**NUMBER:** 23-004-05

Door Glass Misalignment Or Contacts The Roof

This bulletin involves replacing the upper nut securing the window regulator to the door.

2004 - 2005 (ZH) Crossfire Coupe/Crossfire Roadster

**Fig. 1 WINDOW REGULATOR**

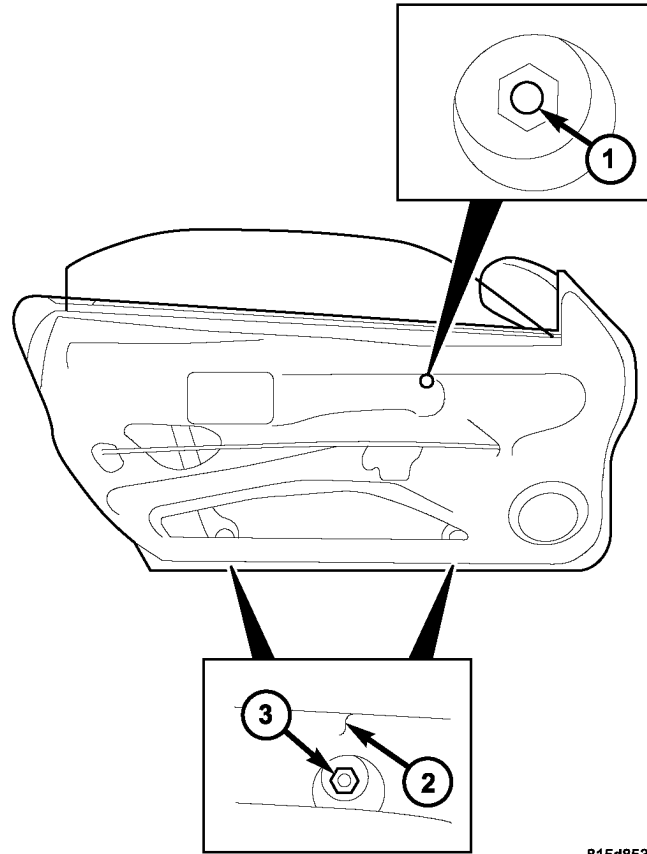
1. Remove the trim panel and weather shield from the door. Refer to the service information available in TechCONNECT. Reference: Service Info, Group 23 - Body/Door - Front/Trim Panel - Removal.
2. Replace the upper window regulator nut with p/n 05097674AA nut ([Fig. 1](#)).

**NOTE: If p/n 05097674AA nut is not available, the technician may remove the old nut and apply p/n 04318031 Mopar Lock & Seal Adhesive to the threads of the nut and install.**

- 
- 3. Adjust the door glass as necessary and ensure that the door glass no longer contacts the roof. Refer to the service information available in TechCONNECT. Reference: Service Info, 23 - body/Door - Front/Door Glass - Adjustments.
  - 4. When the glass is properly adjusted, torque the upper nut to 9 N·m (80 in. lbs.).
  - 5. Install the door trim panel. Refer to the service information available in TechCONNECT. Reference: Service Info, Group 23 - Body/Door - Front/Trim Panel - Installation.
